Re: BZA Case No. 17309 – Dorchester Associates/Chain Bridge Road

Enclosed please find the original and 20 copies of the Applicant's Supplement to its Prehearing Statement for BZA Case No. 17309. This Supplement includes:

Re: **Chain Bridge Road Project**
Revisions 3.24.2006

Chain Bridge Road Project

(Reuse Existing Road)
Road Alignment
Chain Bridge Road Project
Square 1425 Lot 827, Parcels 12/63, 12/293 and 12/294
Washington, DC

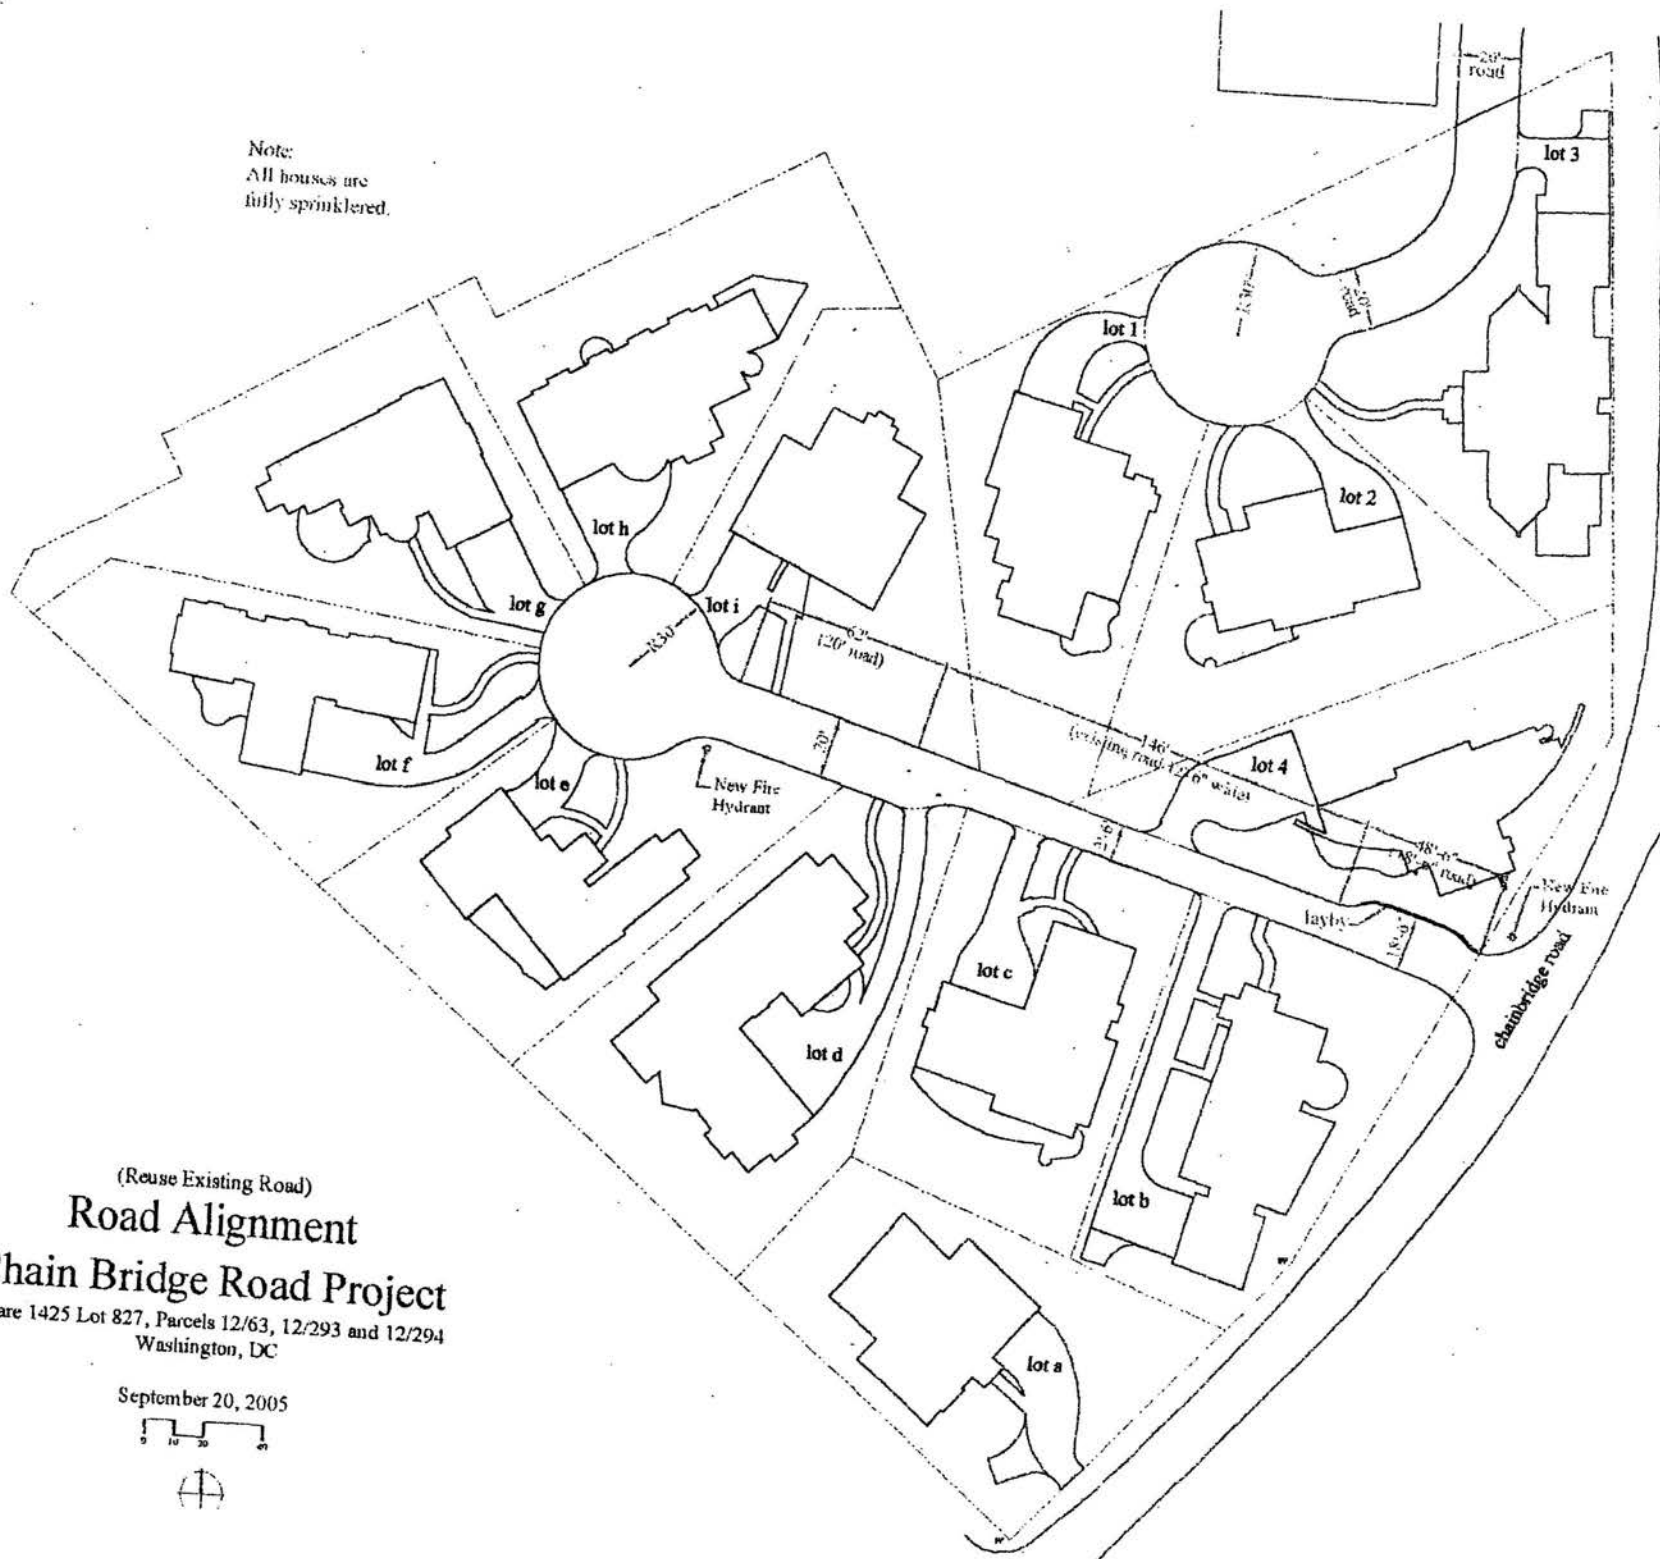
Mr. Bender has proposed to widen the first 48 feet of the roadway at the entrance to Chain Bridge Rd to 18' 6", [see attached diagram], and the last 62' of the roadway to the cul-de-sac widened to 20'. This would leave a portion of the original road, a length of 146', at a minimum of 12'6" in some portions. To assist Fire Department operations, he proposes to install hydrants at the entrance to the property at Chain Bridge Rd., and also in the cul-de-sac at the end of the road. There are also hydrants on Chain Bridge Rd. within 300 feet of the entrance to the property. All of the proposed home sites will be sprinklered per code requirement, with municipal water supplies.

Mr. Bender is requesting a variance of the required road width as indicated in the 2000 ICC Fire Code, which indicates that apparatus access roads shall have an unobstructed width of **20'** [Sec.503.2.1].

After reviewing your request, and the proposed development plans listed in your letter dated September 27, 2005, and an on-site visit to the property, your request for a variance is approved.

Proposed Grading Plan
Chain Bridge Road Project
Square 1425 Lot 827, Parcels 12/63, 12/293 and 12/294
Washington, DC

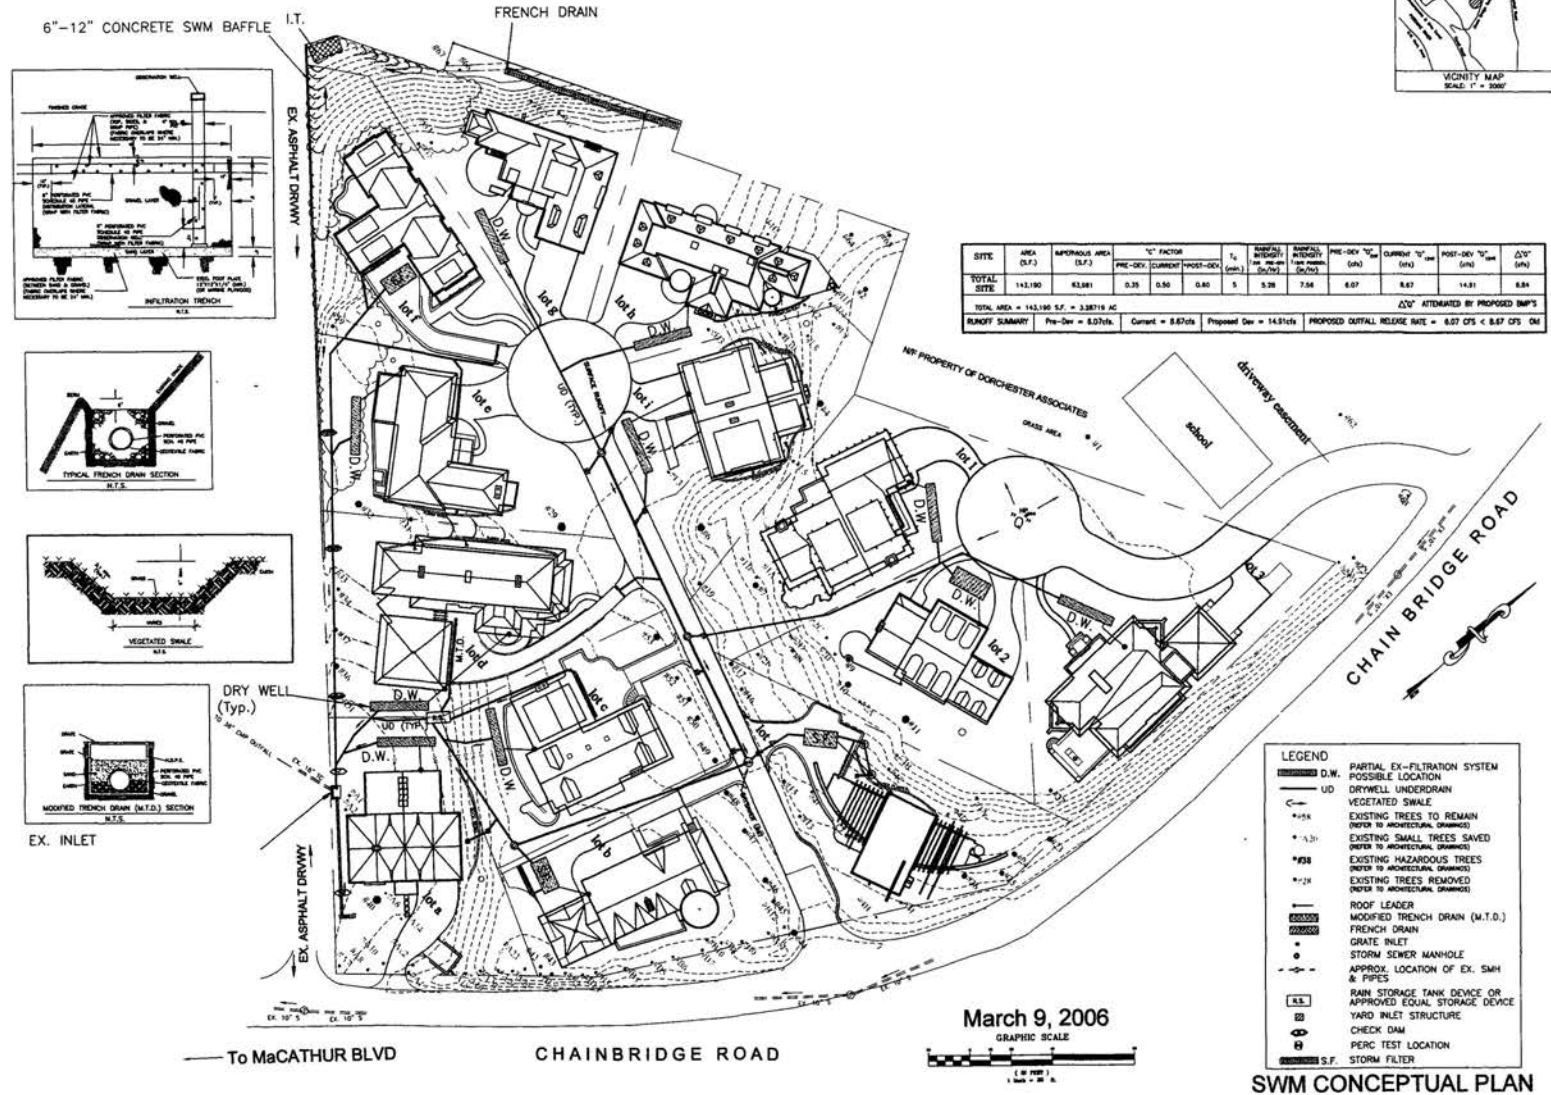
The Storm Water Management Plan was revised in consultation with the Project Arborist to minimize any potential effect on existing trees. Proposed drains and dry wells were relocated away from the root structure of existing trees. The proposed Grading Plan was revised to reflect the changes in the SWM Plan and to reduce the amount of changes in the grade of the site. The Landscape Plans were also revised in consultation with the Project Arborist to remove landscaping from under the canopies of existing trees to prevent possible harm to their root structures.

Lot 3
West Elevation- Lowered House
March 24, 2006

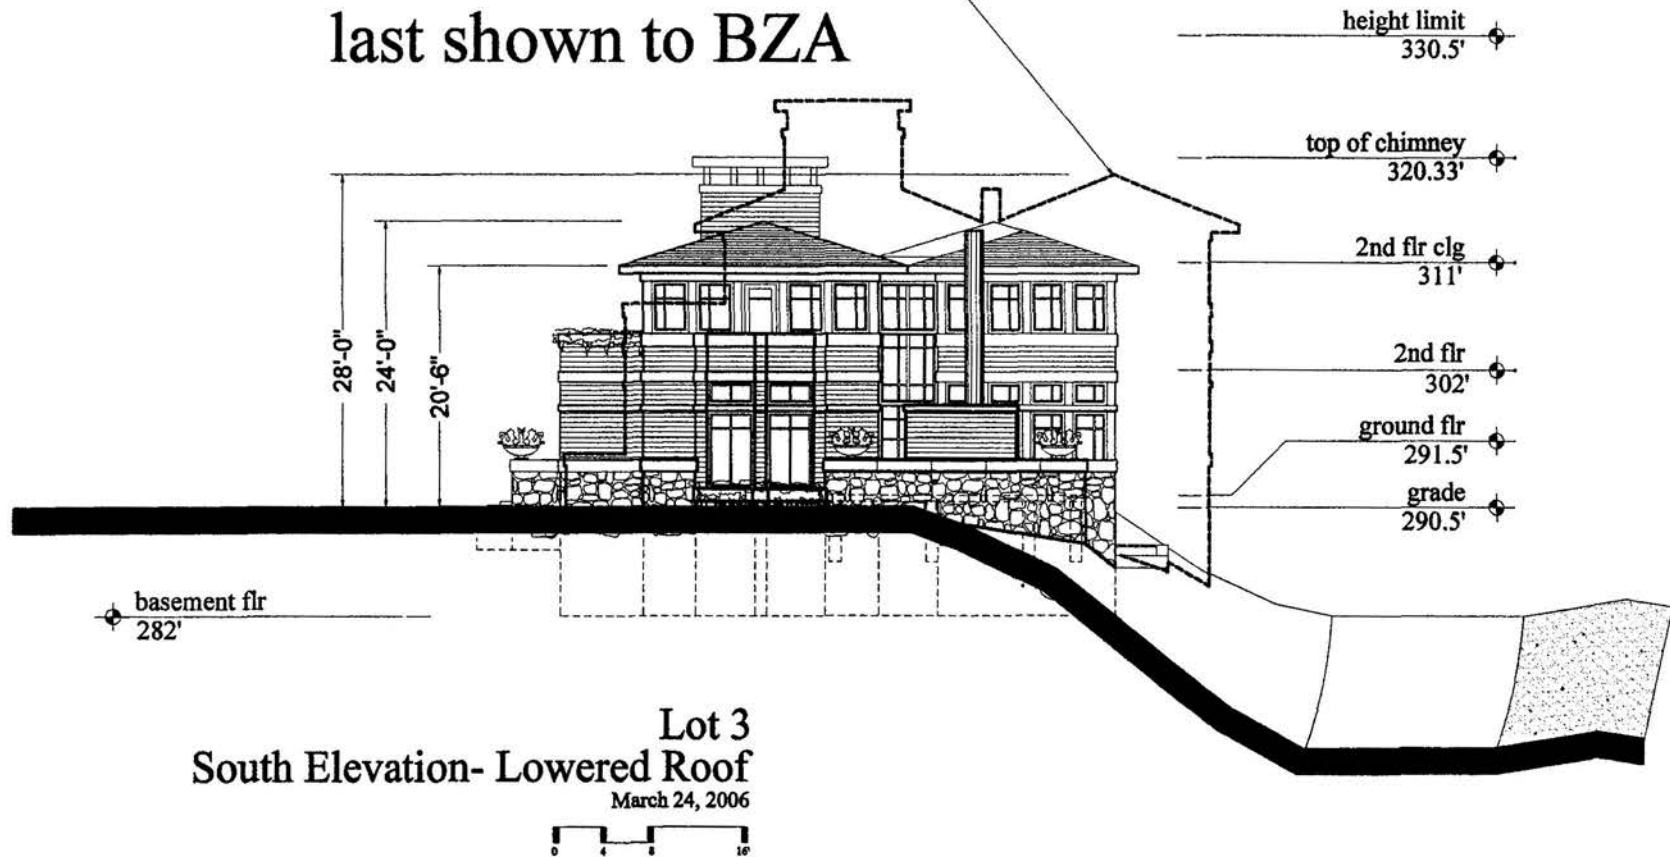
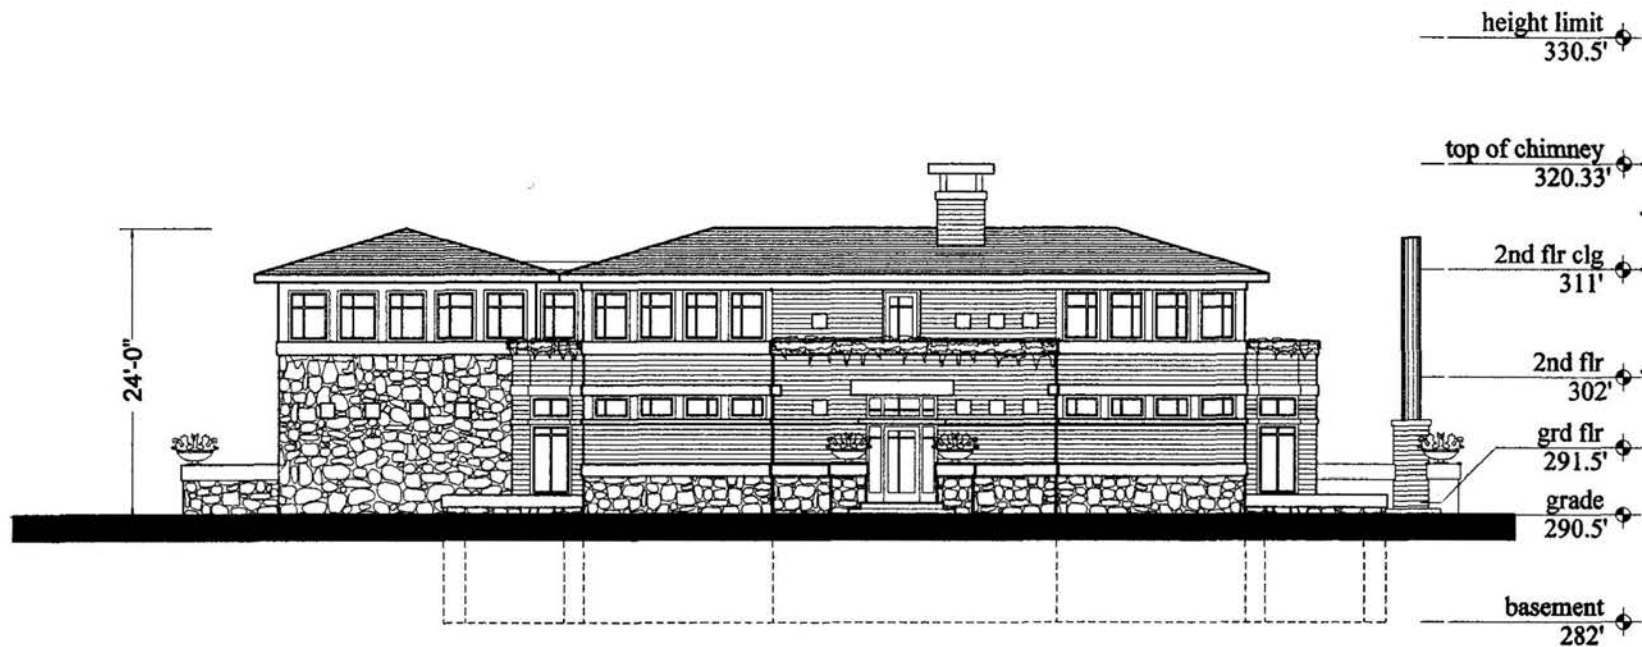
The House Plans were revised in response to concerns raised by various parties including the Office of Planning, the Park Service and the community. The house proposed for Lot 3 has been setback an additional 8 feet (approximate) from Chain Bridge Road and its height was lowered by approximately 5 feet, leaving it approximately 19 feet below the height limit. We reduced the size of the house on Lot F and gave it a larger setback from the neighboring property. The proposed height of the house is now approximately 19 feet below the height limit and the setback from the neighboring property line has been increased to 25 feet. The Applicant has also reduced the height of the house proposed for Lot G by approximately 13 feet, leaving it substantially below the height limit.

Outline of House last shown to BZA

Lower ground floor 6"
Decrease ground to second flr 6"
Decrease second to ceiling 6"
Lower roof height 14"
Total 32"

Lot G
South Elevation
Chain Bridge Road Project

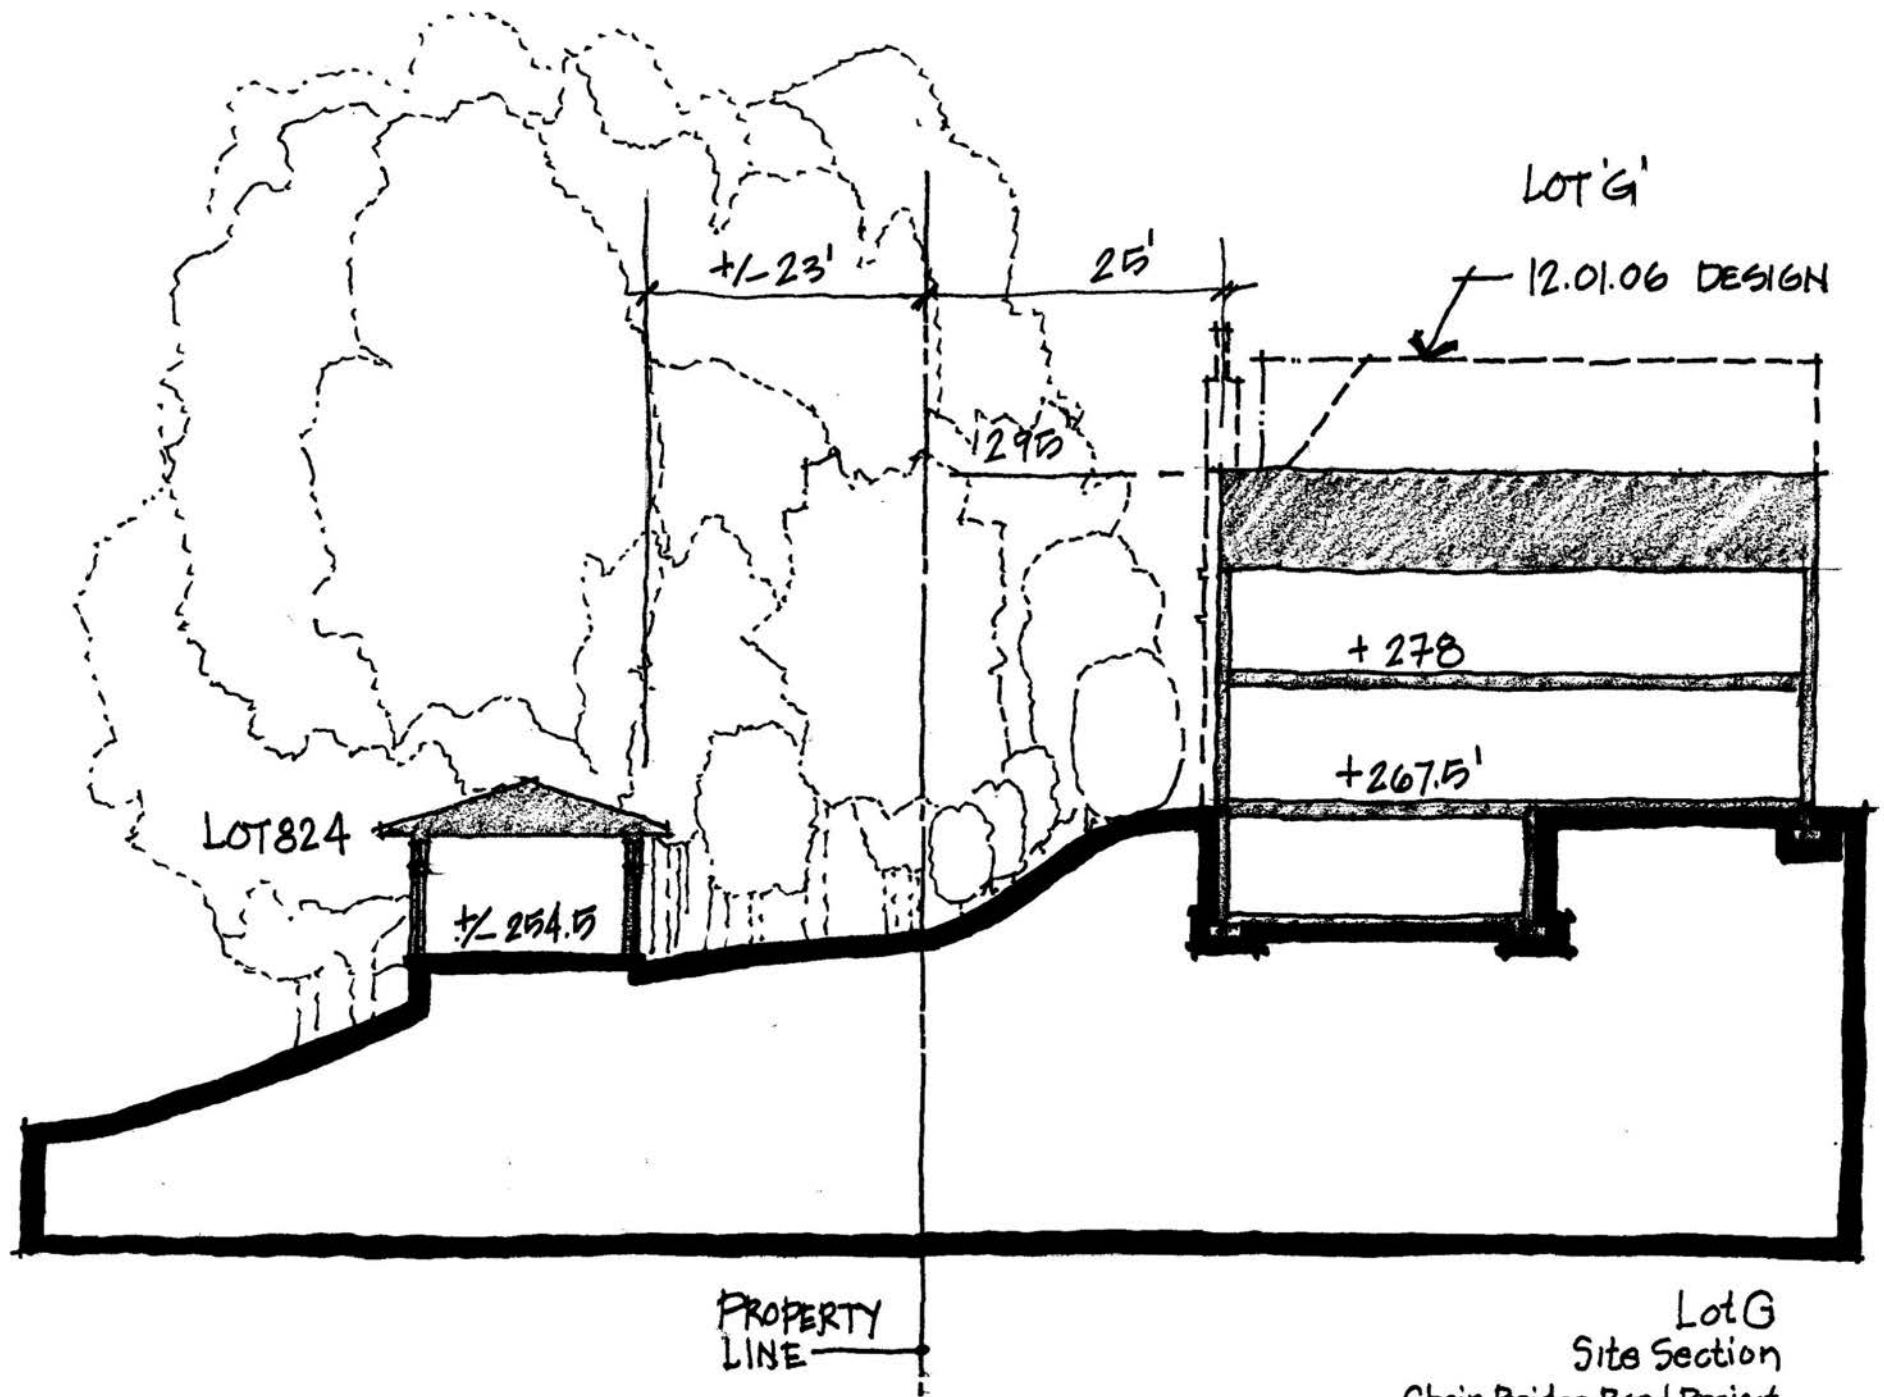
~~December 1, 2005~~ MAR. 24, 2006 REDESIGN

Cellar	~~1,663~~ sf	1600 SF
Basement	~~263~~ sf	250 SF
Ground Floor	~~2,466~~ sf	2400 SF
Second Floor	~~2,379~~ sf	2100 SF
Total	~~6,771~~	6350 SF ±
